METROPOLITAN GOVERNMENT OF NASHVILLE AND DAVIDSON COUNTY

STAFF RECOMMENDATION
1035 Chicamauga Avenue
March 16, 2016

Application: New construction—infill
District: Greenwood Neighborhood Conservation Zoning Overlay
Council District: 06
Map and Parcel Number: 08305005300
Applicant: James Sweeney
Project Lead: Melissa Baldock, melissa.baldock@nashville.gov

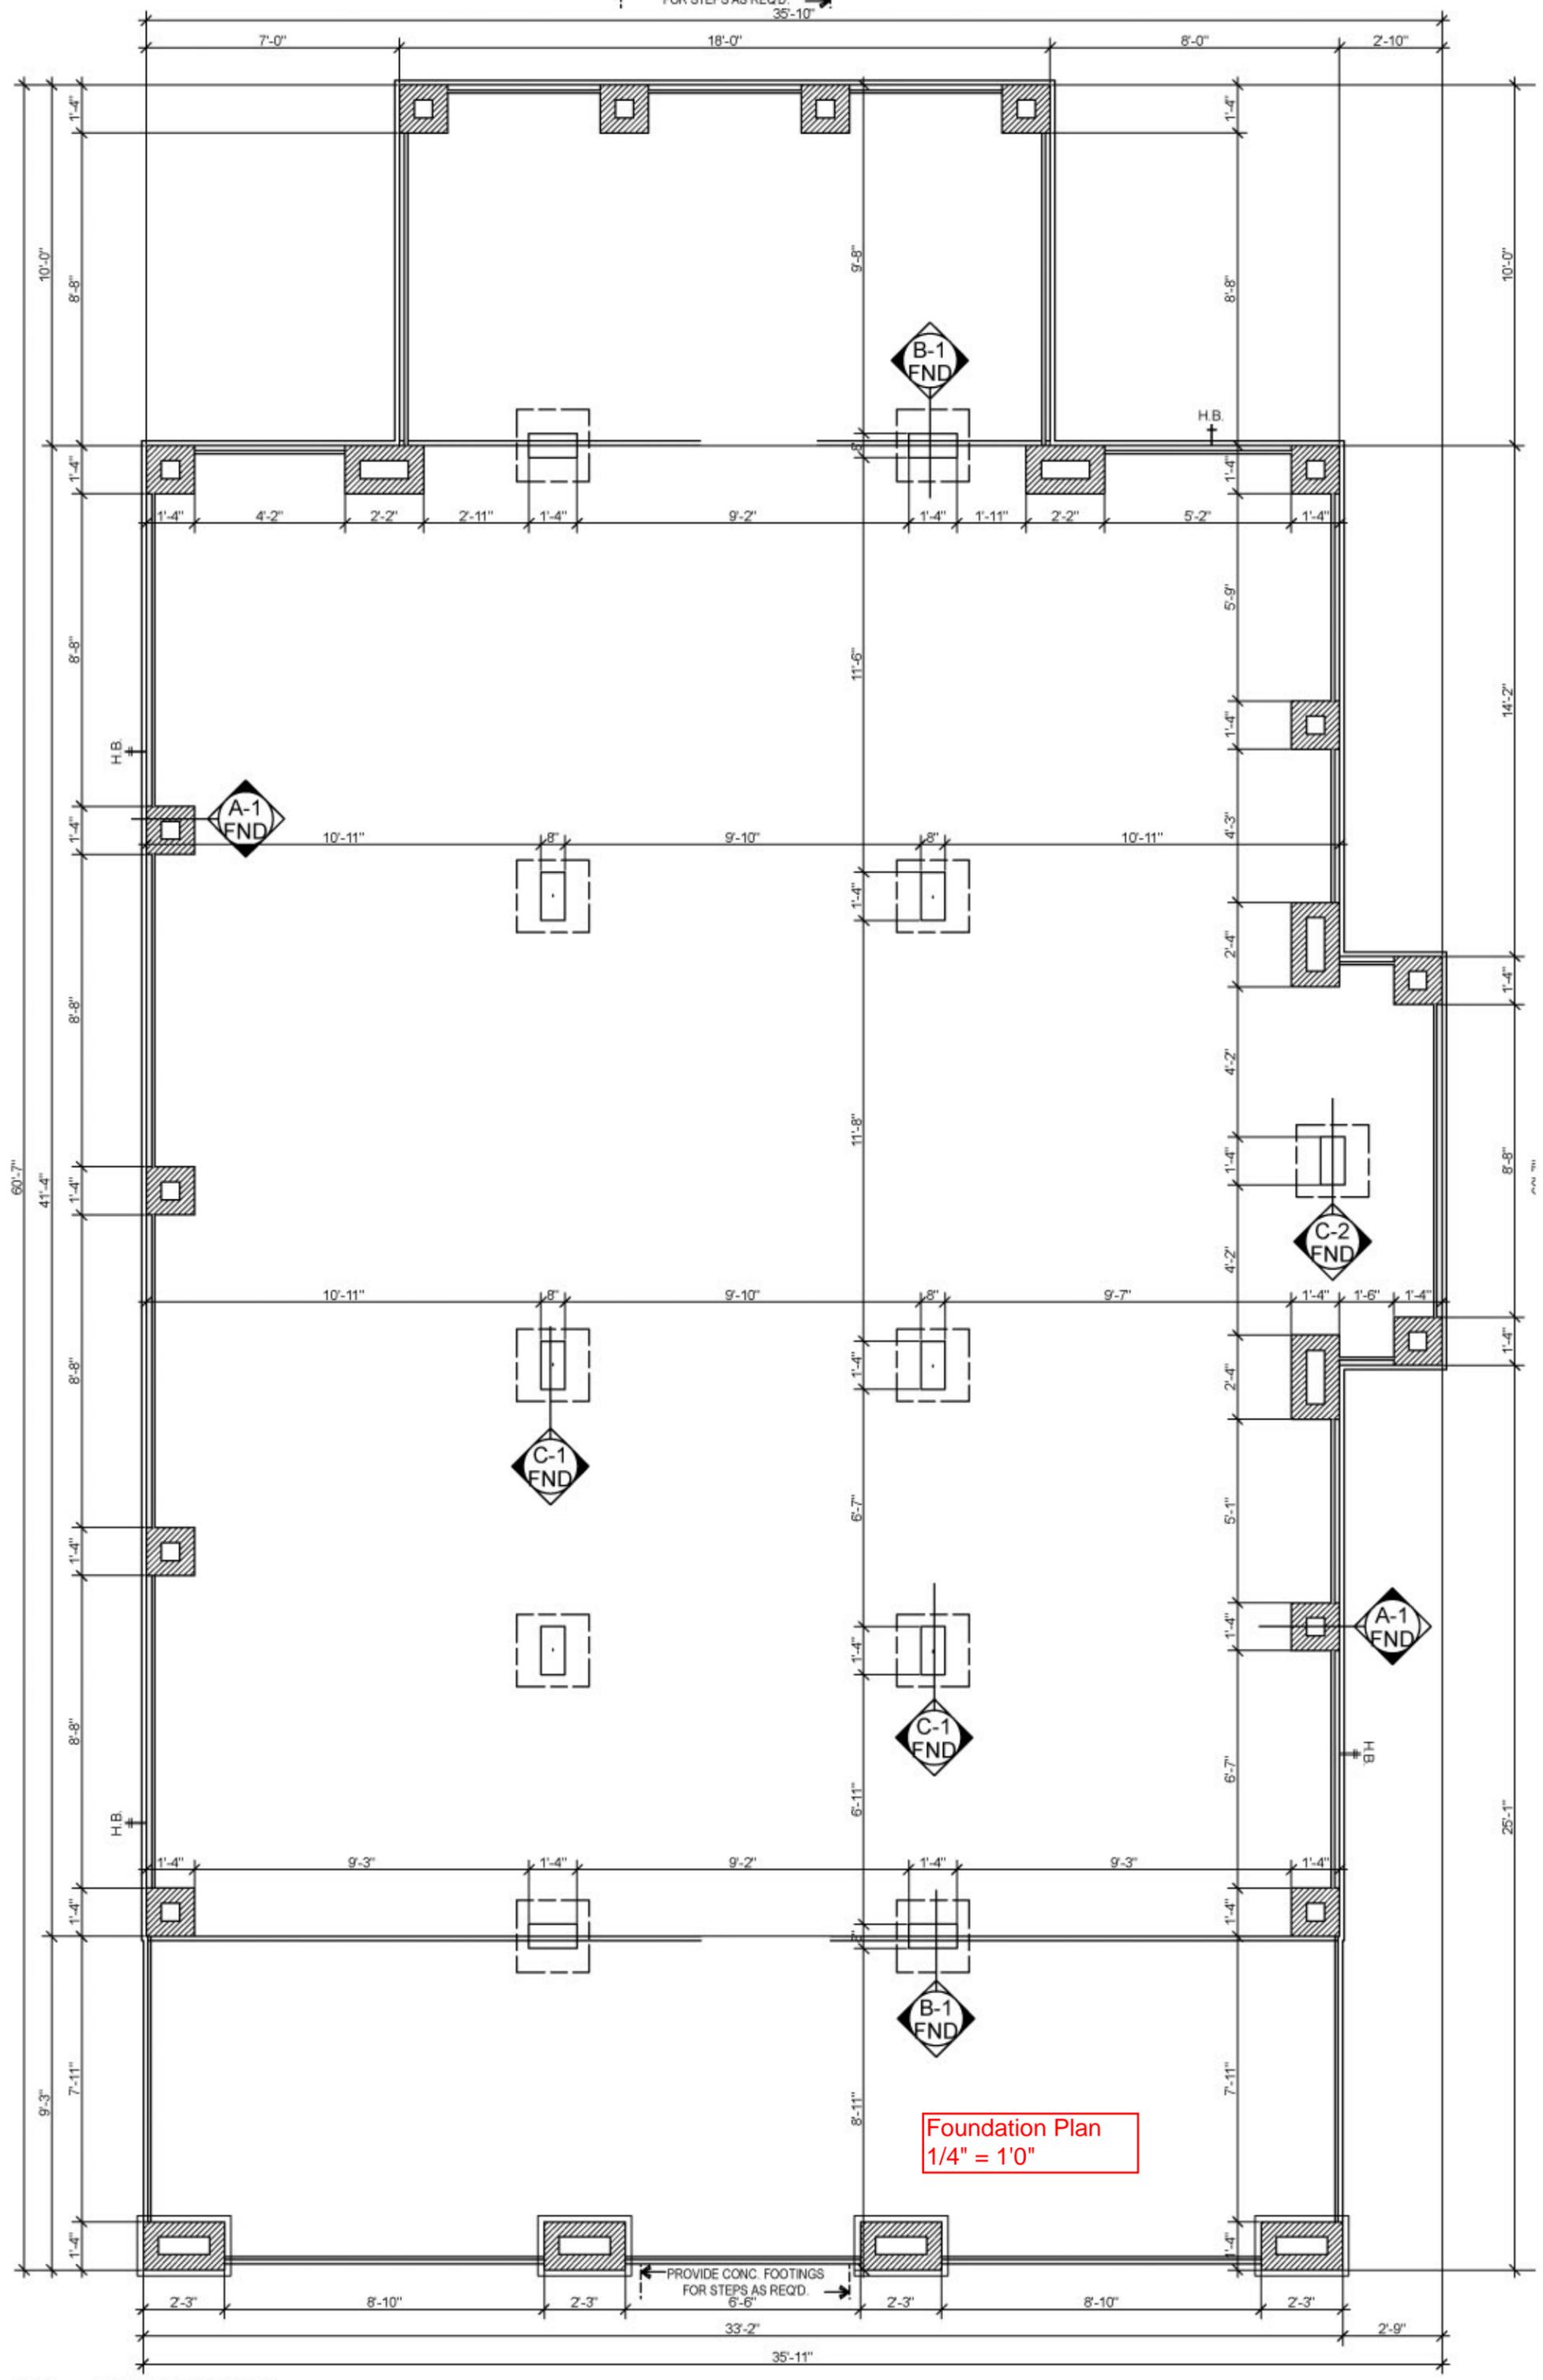
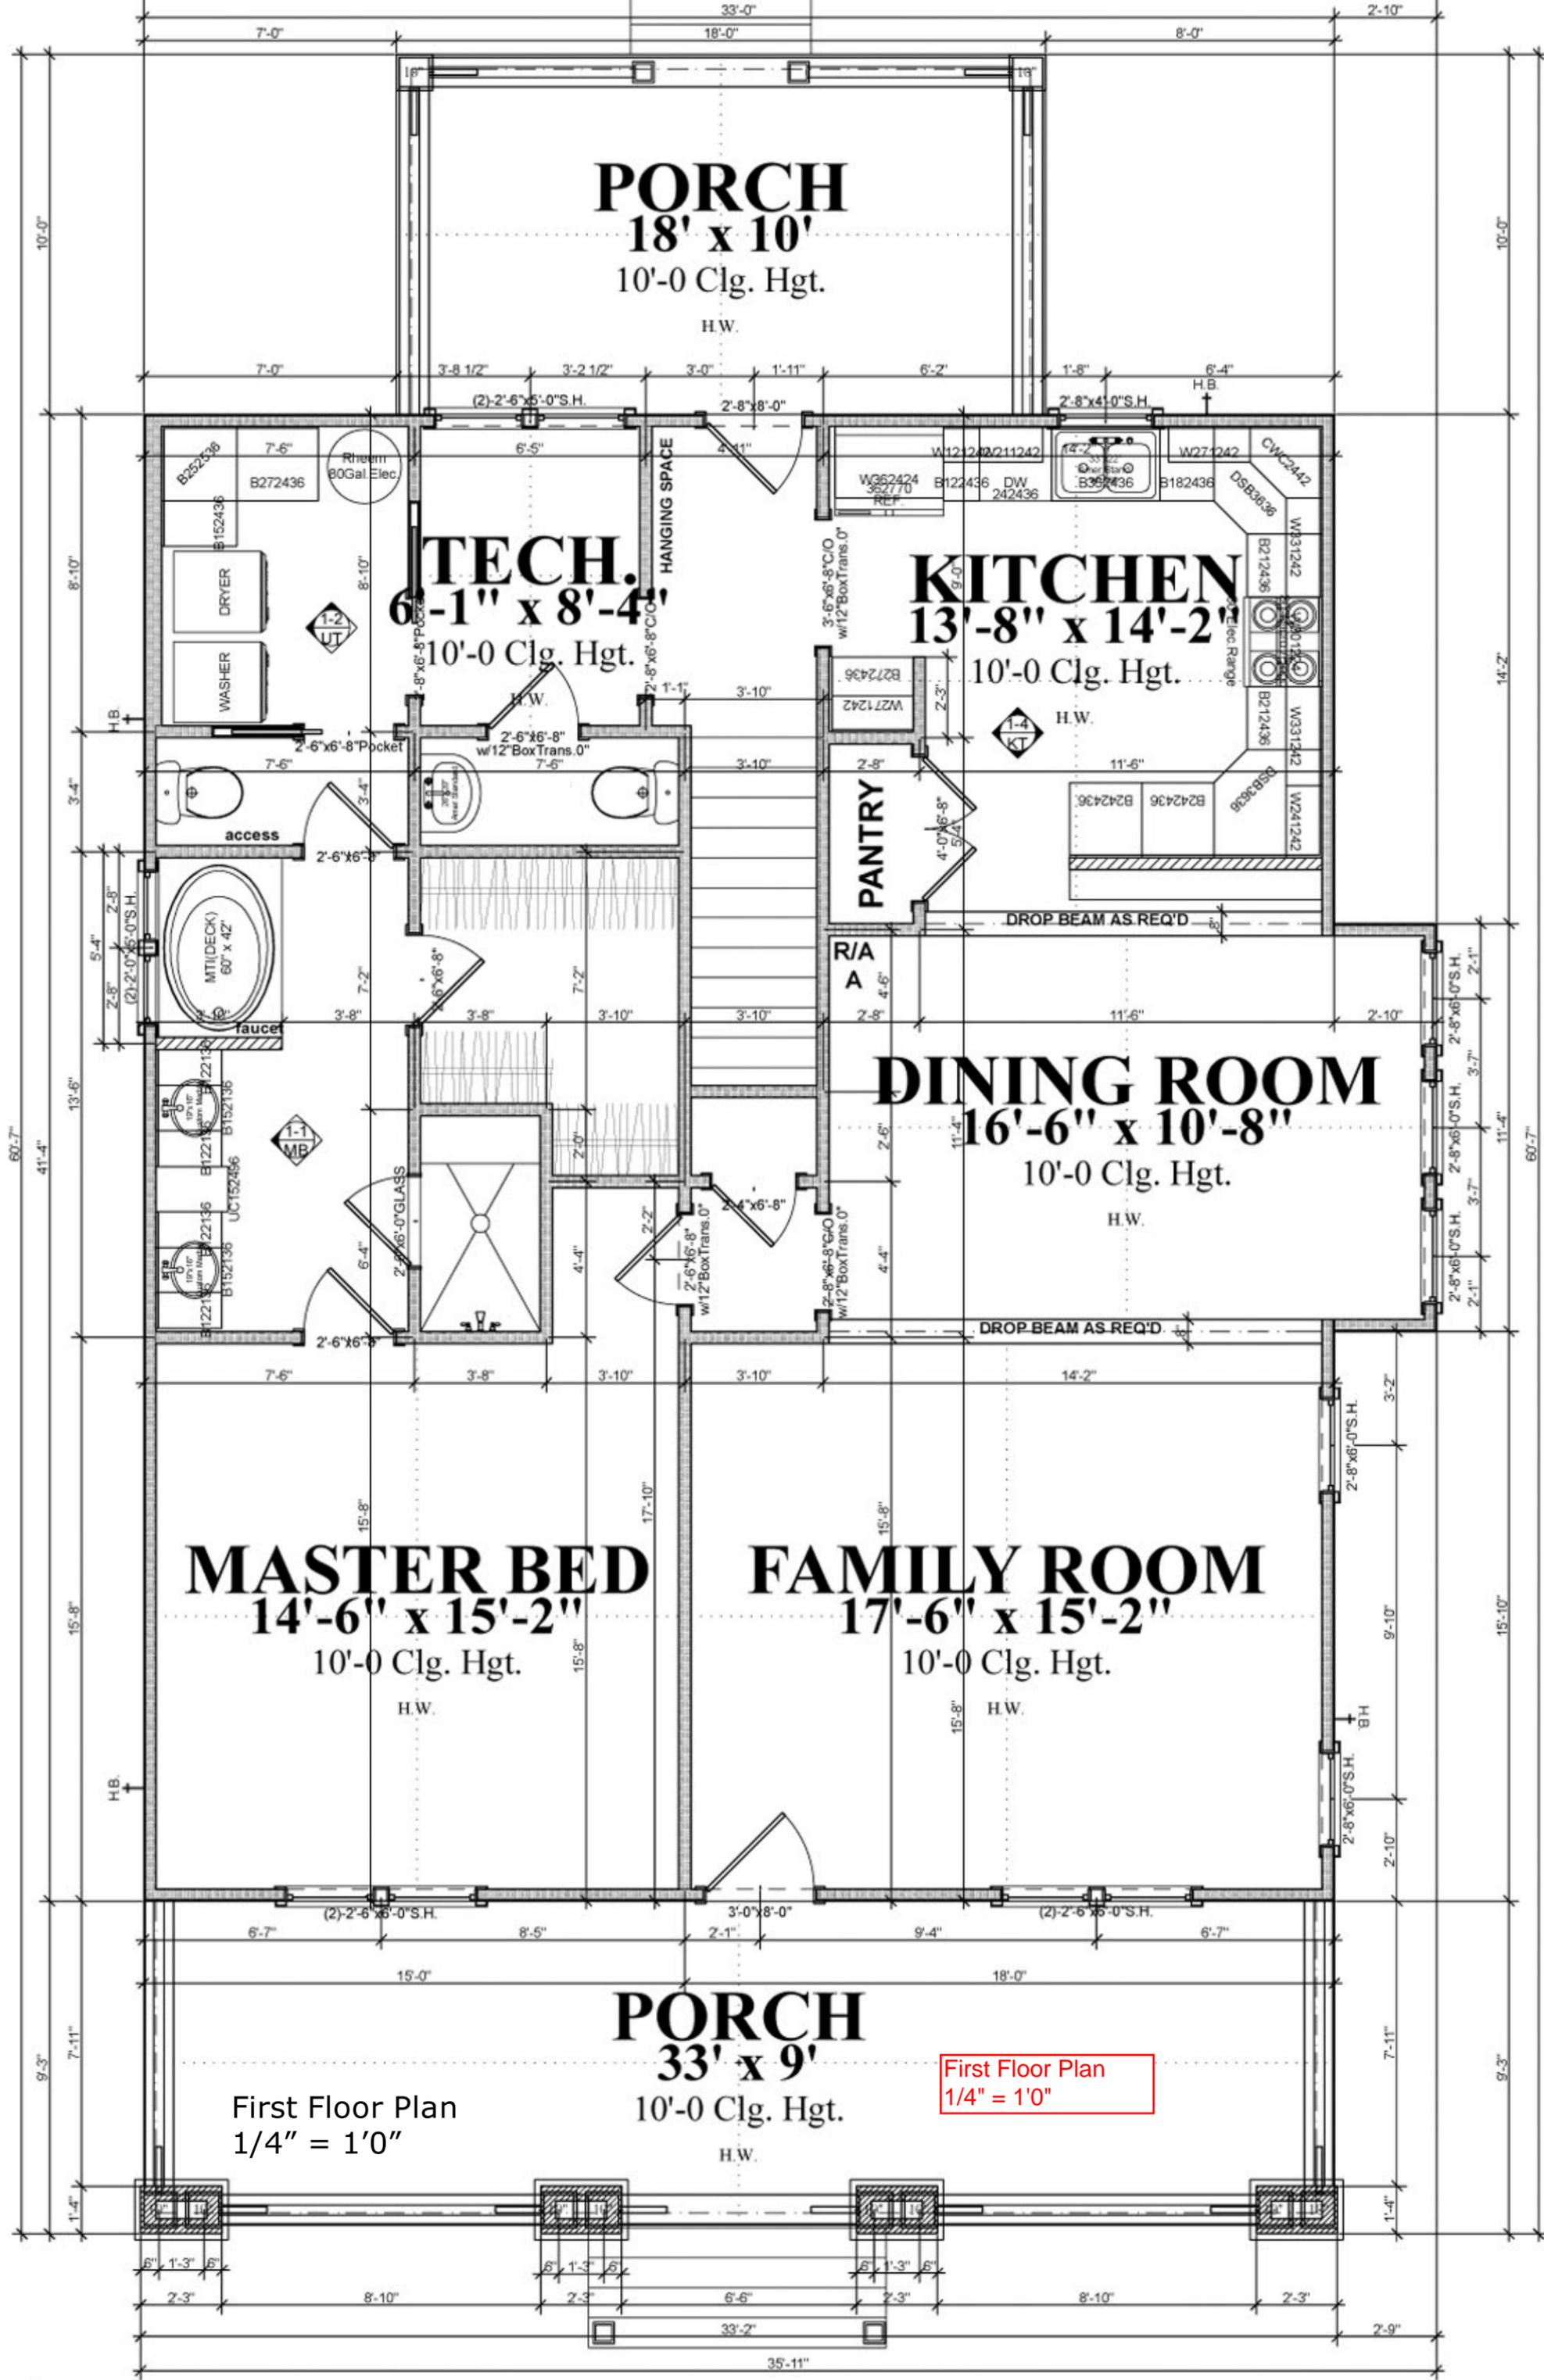
Setback & Rhythm of Spacing: The proposed infill will be shifted to the right/east side of the lot so that it is five feet (5') from the right/east side property line and approximately ten feet (10') from the left/west side property line. This is typical in the neighborhood, as many houses are not centered on their lots. Staff notes that the site plan shows the bay as being located on the left/west side façade of the house, while the elevations and floor plans show that the bay is to be located on the right/east side. Staff recommends that the site plan be corrected to show the correct location of the bay and to ensure that no portion of the new infill sit closer than five feet (5') from the side property line.

The site plan indicates that the front porch will be approximately twenty-five feet (25') from the front property line and the front wall of the house will be approximately thirty-four feet, three inches (34'3") from the front property line. The site plan does not show the setbacks of the two adjacent houses, but staff's analysis of the Metro Maps indicates that the proposed front setback is further back by ten to fifteen feet (10'-15') than the setbacks of the two adjacent houses. Staff recommends that the site plan show the front setbacks of the two adjacent houses, and that the infill's front setback be the average of the two adjacent houses' setbacks. With the changes to the site plan and the front setback, staff finds that the infill's setback and rhythm of spacing meet Section II.B.1.c. of the *Greenwood Neighborhood Conservation Zoning Overlay: Handbook and Design Guidelines*.

Appurtenances & Utilities: The site plan indicates that a French drain will be created along the left/west side of the property. Two cisterns of seven hundred and fifty-gallons each will connect to the French drain, and staff recommends that the applicant provide more information on the materials and design of these cisterns. Staff also recommends approval of the HVAC location.

1. The finished floor height shall be consistent with the finished floor heights of the adjacent historic houses, to be verified by MHZC staff in the field;
2. The site plan show the accurate location of the side bay, and show that no part of the house will be located closer than five feet (5') from the side property lines;
3. The site plan show the front setbacks of the two adjacent properties, and the infill's front setback be the average of the two adjacent houses' setbacks;

1E FRONT ELEVATION
SCALE: 1/4" = 1'-0"

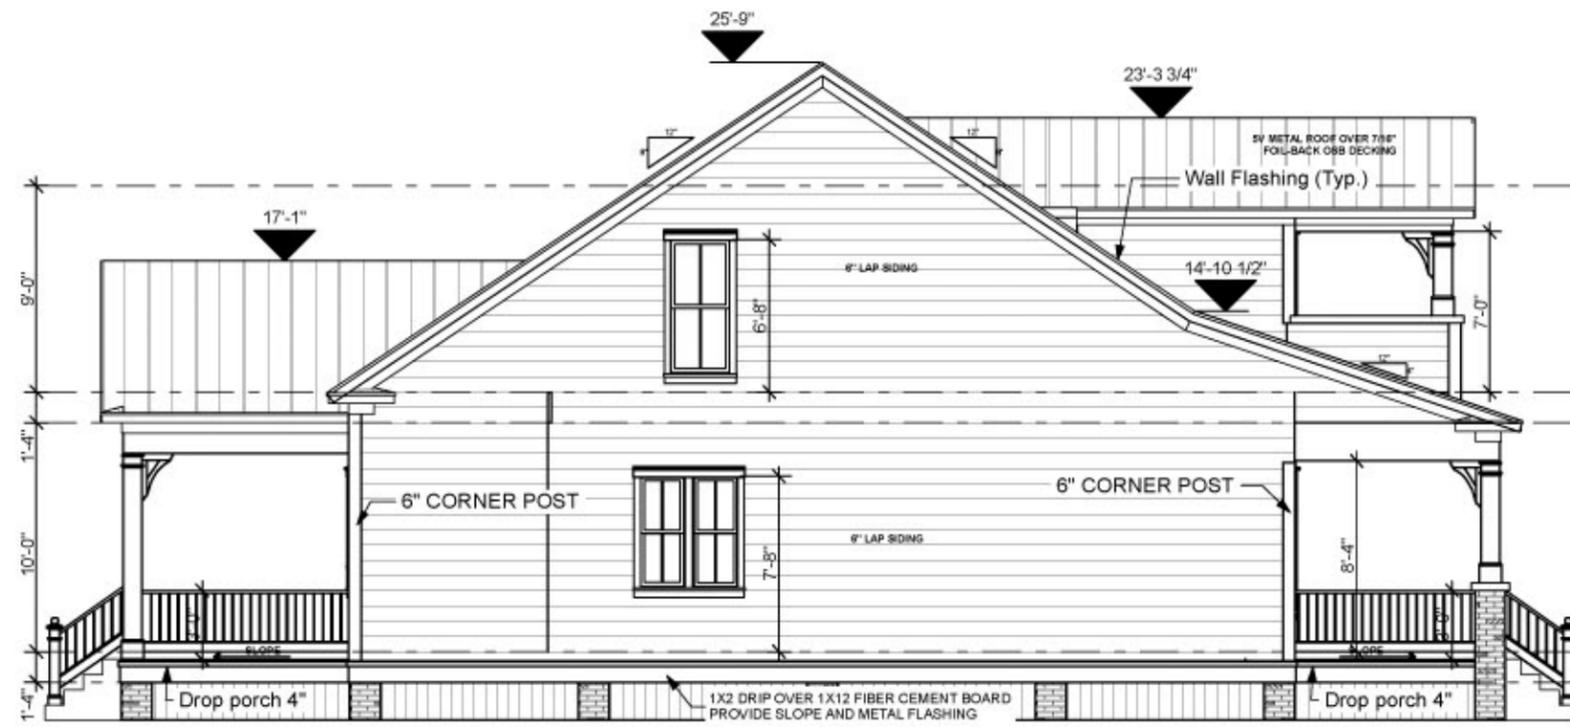
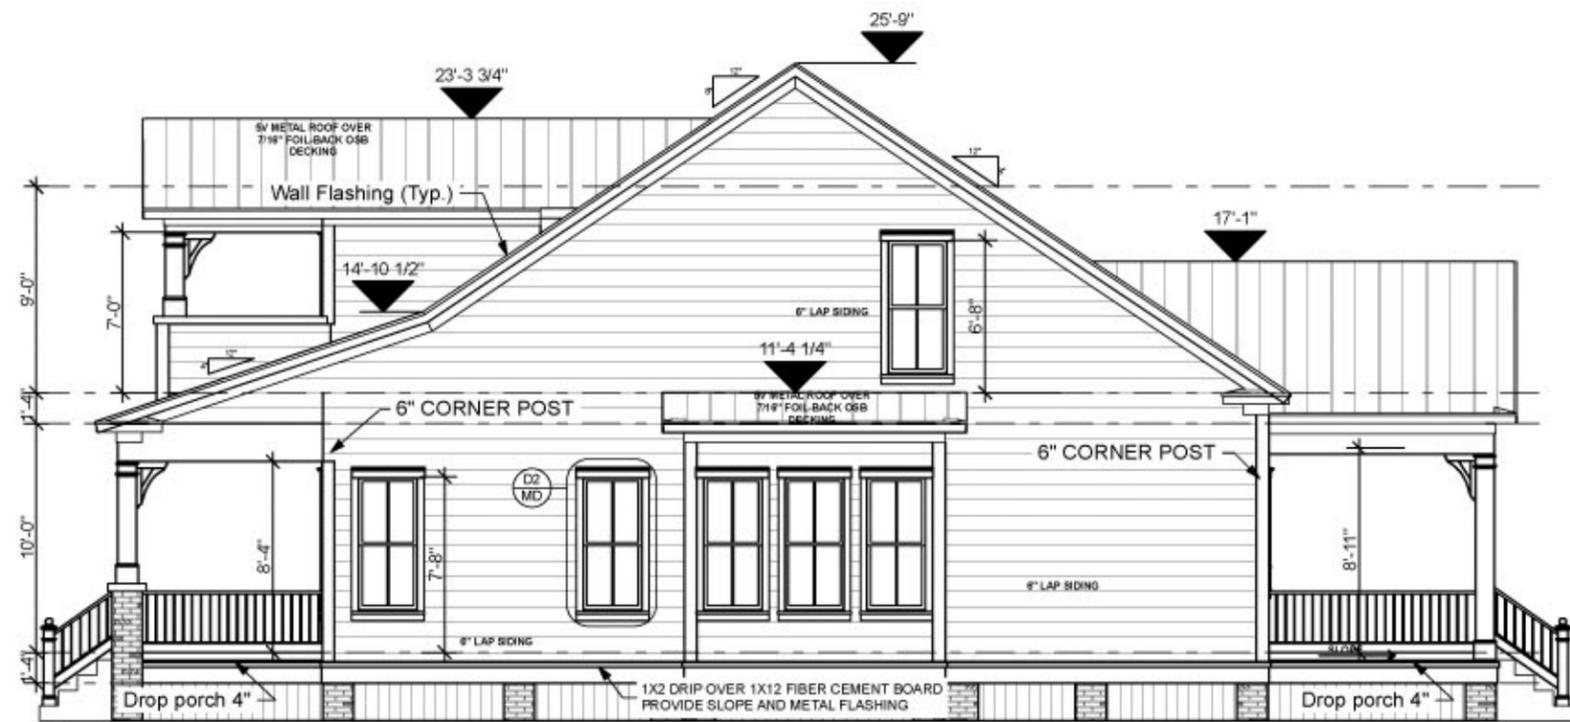
The front façade includes a gabled dormer with a covered porch extending off of the dormer. Staff finds that the proposed front dormer does not meet the design guidelines. The wall of the dormer stacks on the wall below, and staff recommends that the dormer wall be situated a minimum of two feet (2') from the wall below. The porch off of the dormer extends seven feet, three inches (7'3") beyond the historic house's wall and over the porch roof. Staff finds that there is no historic precedent for a dormer porch to be this deep. Examples of historic dormers with shallow balconies off of them show that when there are balconies off of dormers, the dormers are set back a minimum of two feet (2') from the wall below, the dormer balcony does not extend any further beyond the front wall of the house (Figures 3-6) and that the porch portion is minimal depth at approximately three feet (3'). They do not extend over the porch roof extensively as is proposed. Staff therefore recommends that the dormer be inset a minimum of two feet (2') from the wall below, and the balcony be limited to extending no further than the front wall of the house. With this condition, staff finds that the infill's roof forms meet Section II.B.1.e. of the *Greenwood Neighborhood Conservation Zoning Overlay: Handbook and Design Guidelines*.

Proportion and Rhythm of Openings: The windows on the front façade meet the proportion of historic window openings, as they are at least twice as tall as they are wide. The dormer windows are taller than typical dormer windows, but if the dormer is set back two feet (2') from the wall below, the size of the dormer windows will be less visible. On the left/west side façade, there is an expanse of over twenty-four feet (24') from the front wall of the house to the next window opening without a door or window opening. Staff recommends the addition of at least two window openings in this expanse. With these changes, staff finds the infill's proportion and rhythm of openings meet Section II.B.1.g. of the *Greenwood Neighborhood Conservation Zoning Overlay: Handbook and Design Guidelines*.
